E4443A-07A

S E R V I C E N O T E

PSA Series Spectrum Analyzer

E4440A, E4443A, E4445A, E4446A and E4448A

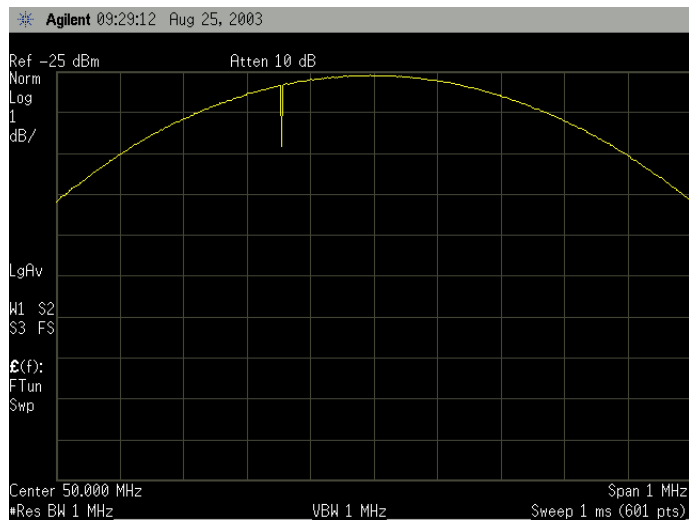
A hardware defect has been detected in the above range of PSA series spectrum analyzers. This defect can cause measurements to be made not to the specified performance of the instrument. The effected assembly is the A7 Digital IF assembly. Customer notifications will begin in early October, 2003. Please perform the following procedure to determine if the instrument does require modification.

- Press the PRESET key.
- Tune the instrument to 50 MHz by pressing the FREQUENCY key followed by 50 MHz.
- Set the span to 1 MHz Hertz by pressing the SPAN key followed by 1 MHz.
- Set the Resolution Bandwidth to 1 MHz by pressing the BW/AVG and setting the Res BW to 1 MHz.
- Turn the 50 MHz calibration signal on by pressing the INPUT/OUTPUT key and selecting the Input Port to be the 50 MHz Amplitude Reference.
- Set the Reference level to -25 dBm and the Scale/Div to 1 dB by pressing the Amplitude key.

Effected instruments will randomly show an amplitude drop of approximately 2 to 3 dB.

Replace the A7 Digital IF assembly P/N E4440-60025 or E4440-60195 with the Digital IF exchange assembly P/N E4440-69195. Perform recommended performance verification procedures and possible adjustments. Please reference the PSA Service guide for additional details.
